UNITED STATES PATENT AND TRADEMARK OFFICE

Office Action Summary	Application No. 10/511,070	Applicant(s) JONES, STEVEN VICTOR	
	Examiner Katherine W. Mitchell	Art Unit 3677

DETAILED ACTION

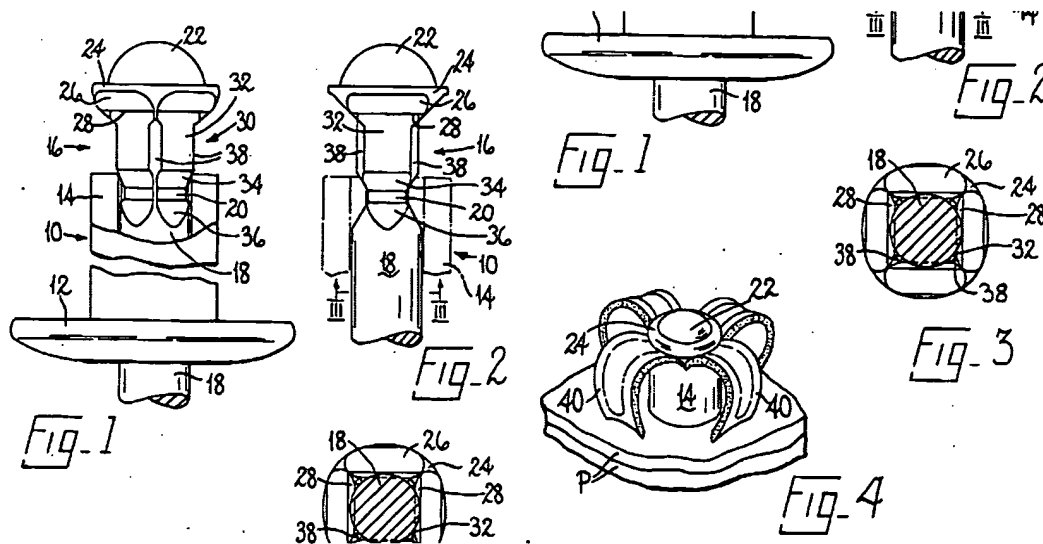
8. Claims 1-2 are rejected under 35 U.S.C. 102(b) as being anticipated by Potzas USP 4620825.

Re claims 1-2: Potzas in Figs 1-4 (above) teaches Potzas teaches a peel type blind rivet (abstract) settable in soft material, having an elongate body 10 with a shank and preformed head 12 at one end, and a plurality of slots 12 terminating at the end remote from the head. There is a mandrel (16, column 2 lines 49-50) having a stem (18) which extends through coaxial with said body and having an enlarged head (22) with a maximum external diameter greater than the internal body diameter (Figs above). The mandrel head forms a shoulder between the mandrel stem and an outer surface of the head, -- the deforming means (head) presents a substantially flat surface perpendicular to an axis of said mandrel, in that the underside of head 22 terminates in plane forming flat shoulders 28 normal to axis of stem, which as shown in Figs 1- 4 and discussed in column 2 lines 62-68 is described as "flat shoulders 28 normal to the axis of the mandrel".
